City of Biddeford
Planning Board
January 25, 2023 6:00 PM City Hall
Council Chambers, & Zoom

STATUS: Planning Board Meeting-January 25, 2023-6:00 PM-City Hall Council Chambers & Zoom

PLANNING BOARD STAFF REPORT

RE: **2023.03 Conditional Use Permit (CUP) for My Place Teen Center (MPTC) to convert the first floor of the former St. Andres Church into a Teen Center for at risk youth ages 10-18 at 75 Bacon Street (Tax Map 39, Lot 130).**

Shared Property Line Issues Detail (Sheet C102)

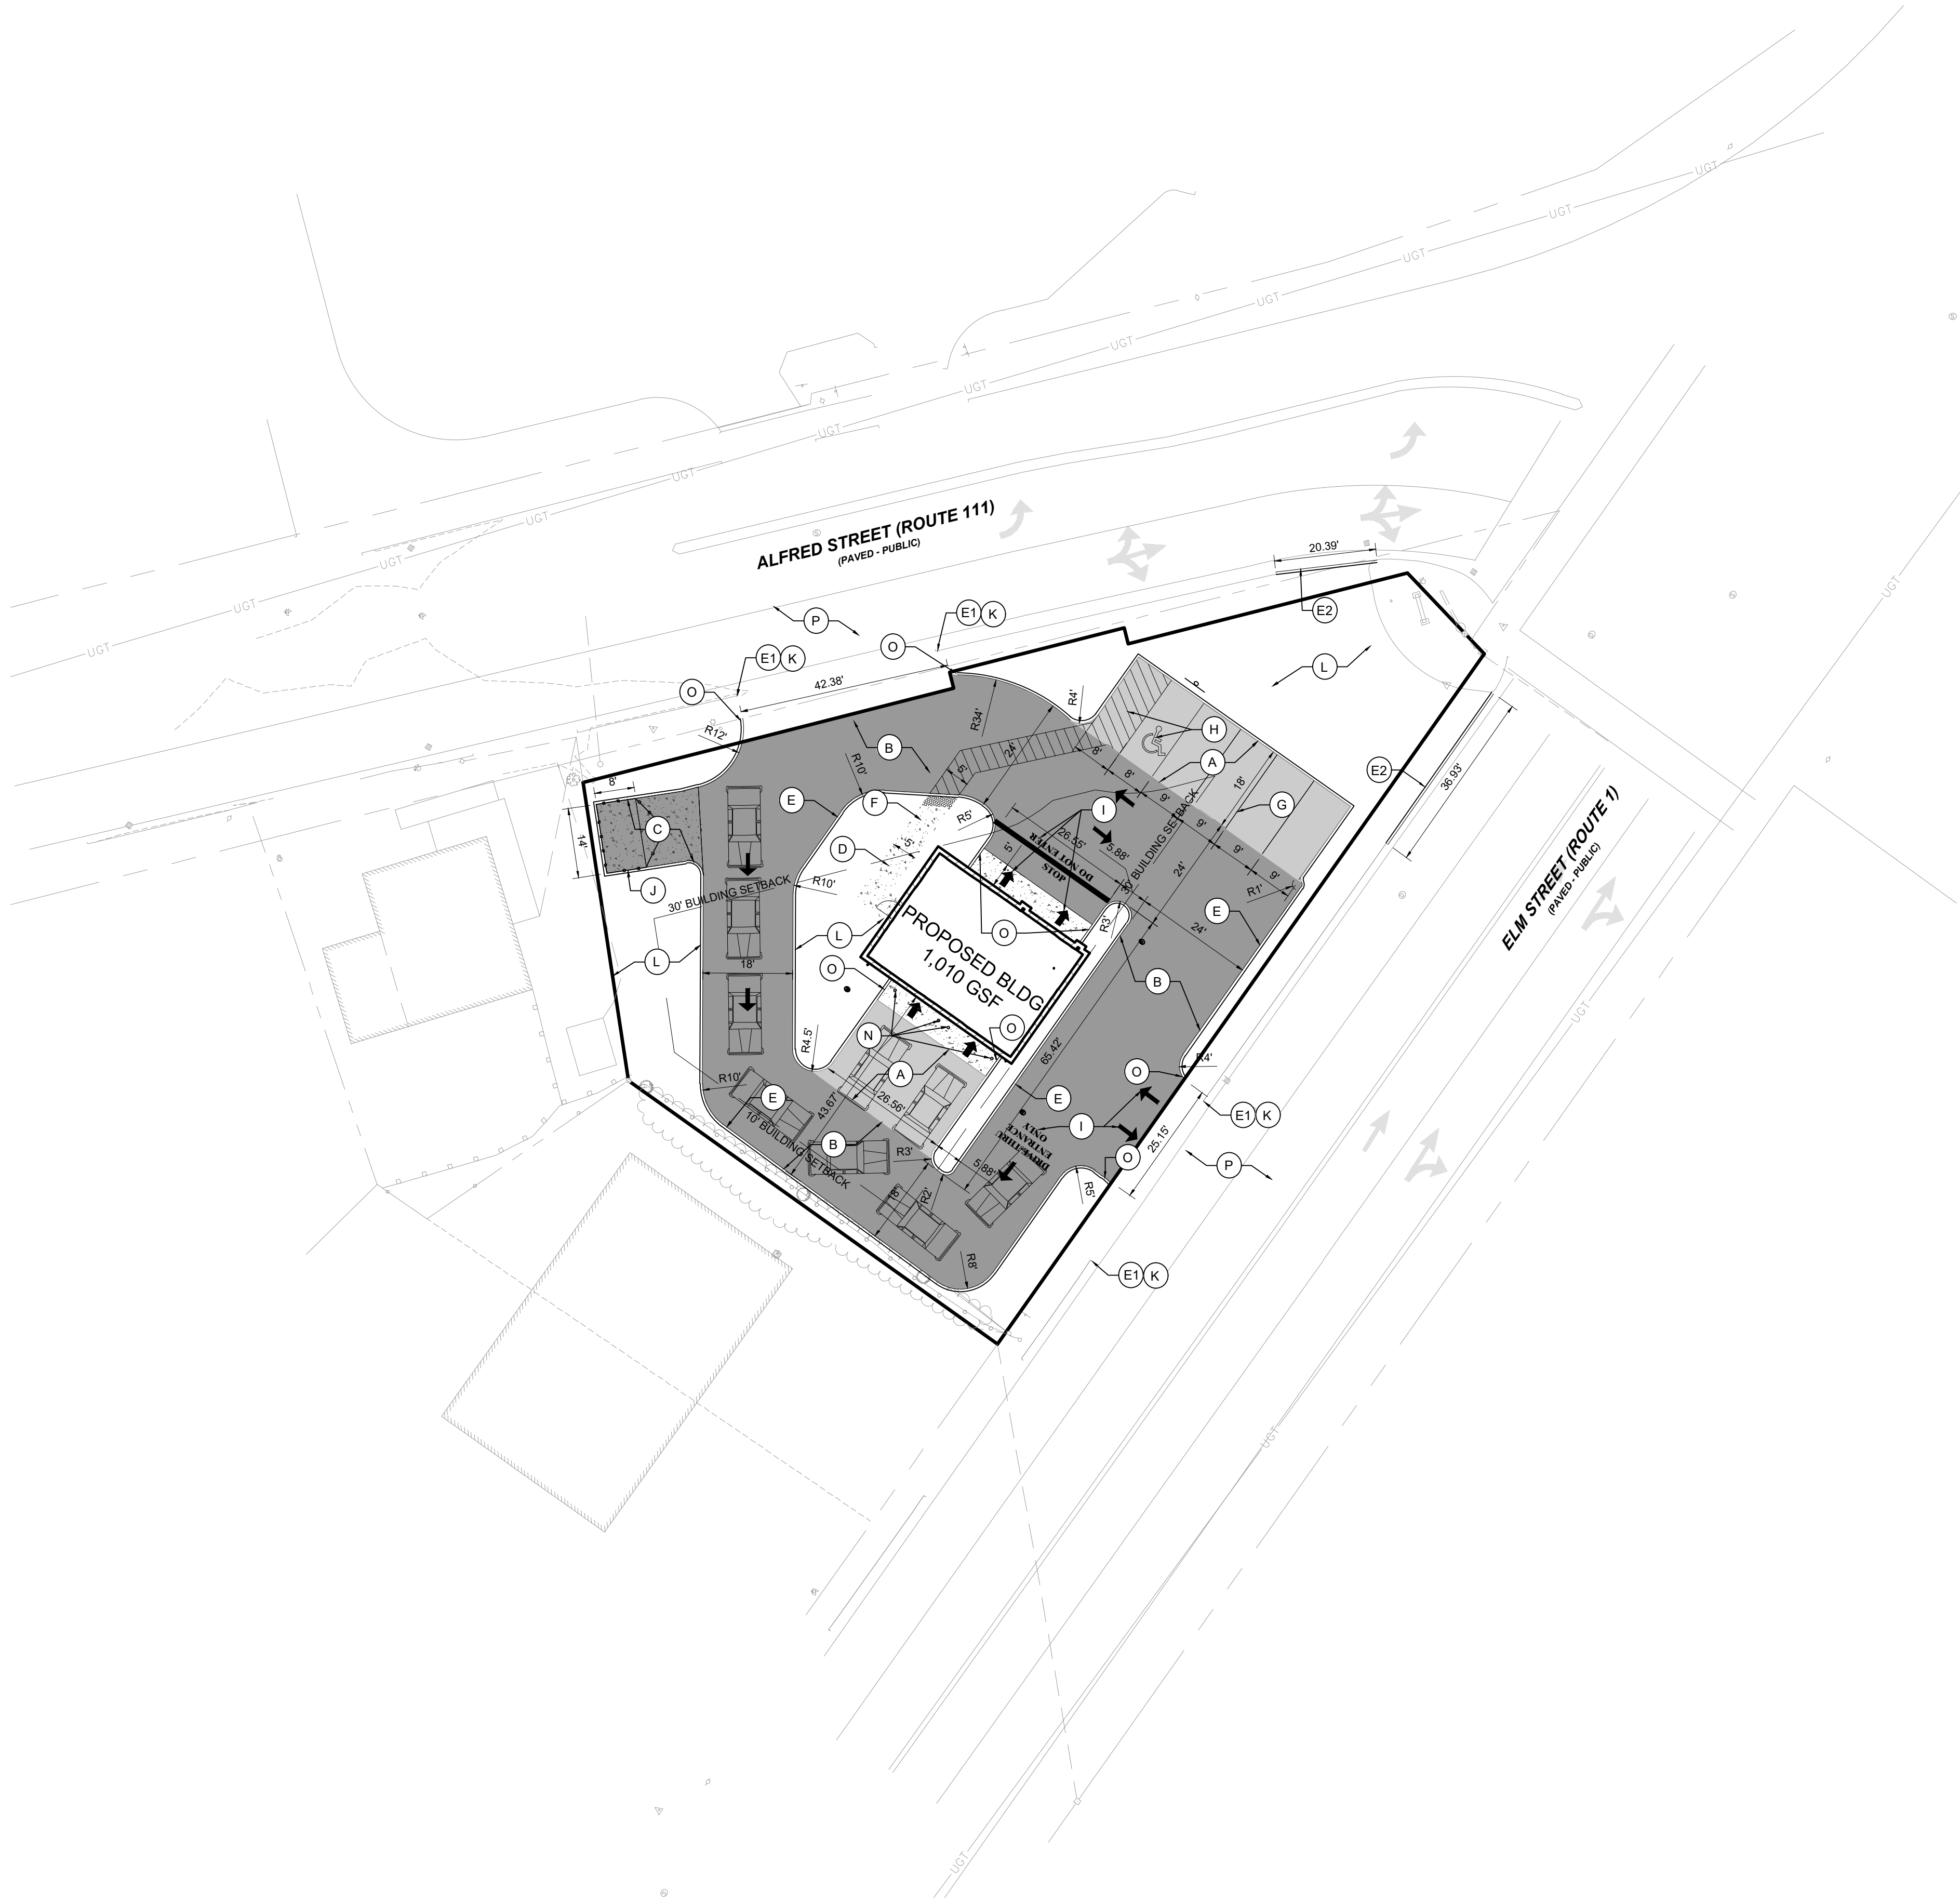
- L. Survey Sheet 1 of 2 (Sheet C102) identifies potential conflicts with the abutting property owner, listed as Mary and Wesley Wratten (Map #20 – Lot 11). This includes the following:
